World Forum for Harmonization of Vehicle Regulations

Proposal for Supplement 3 to the 06 series of amendments to UN Regulation No. 10 (Electromagnetic compatibility)

Submitted by the Working Party on Lighting and Light-Signalling*

"Model A

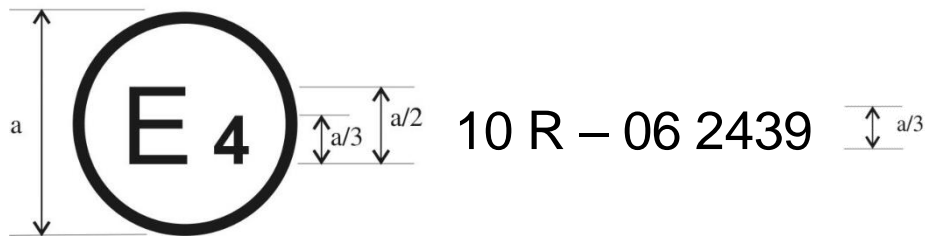
Annex 1, Model A, amend to read:

(See paragraph 5.2. of this Regulation)

$a = 6 \text{ mm min}$

The above approval mark affixed to a vehicle or ESA shows that the vehicle type concerned has, with regard to electromagnetic compatibility, been approved in the Netherlands (E 4) pursuant to Regulation No. 10 under approval No. 06 2439. The approval number indicates that the approval was granted according to the requirements of Regulation No. 10 as amended by the 06 series of amendments."
